Mark E. Jones, PE Structural Engineering and Design

Ref: Site Observations and Analysis 881 McNeil Mill Rd. Broadway, NC Project No: 19-135

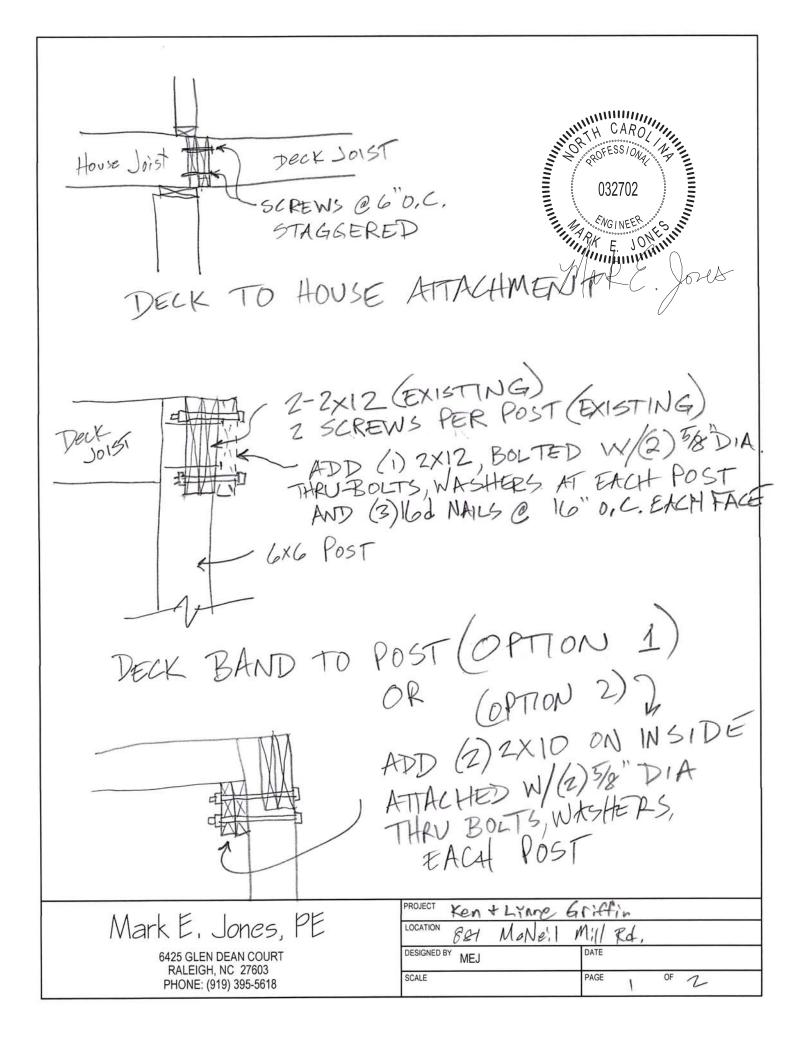
At the original visit several deficiencies were observed and noted, including;

- inadequate attachment of the deck band to the main house
- no diagonal bracing on support posts
- girders and headers spliced within supports
- inadequate connections between the porch posts and floor/ceiling
- handrails not at Code required height
- roof rafters not adequately tied down

- PROVIDE 4X4 DIAGONAL KNEE BRACING 2×6 CROSS BRACING. ATTACH W/ 5/8" DIA. THEN BOUTS TOP AND BOTTOM, ALSO PROVIDE CENTER BLOCK W/THRU BOLT - STAIR HANDRAIL HEIGHT MUST BE BETWEEN 34"-38" RAFTER ADD HZ.SA CUP AT EACH RAFTER 3-2×10 HEADER PROVIDE(2)3'X3"ANGLES - NO SPLICES WITHIN 24" OF EACH OTHER O32702 6×6 - CONNECT WITH (3) 162 NAILS AT 16" O.C. BOTH STDES IN GENERAL - CONNECT WITH (3)162 NAUS AT f'O.C. BOTH SIDES WITHIN 12" OF SPLICE Ken & Lynne Griffin PROJECT Mark E. Jones, PE LOCATION 881 McNeil Rd M:11 DESIGNED BY 6425 GLEN DEAN COURT MEJ RALEIGH, NC 27603 SCALE PAGE 2 PHONE: (919) 395-5618 2

- the deck band has been adequately attached with the required number of fasteners
- diagonal bracing has been installed along the exterior line of the front porch
- a new 2-2x10 girder has been installed on the exterior line of the front porch
- all porch posts have been mechanically fastened at the base and top
- the 3-2x10 headers along the front porch have been adequately repaired
- ceiling joists/rafters have been adequately anchored
- handrails have been corrected to meet Code requirements.
- The side porch headers have been adequately fastened and connected to the support posts.
- The rear steps were observed to be adequately constructed
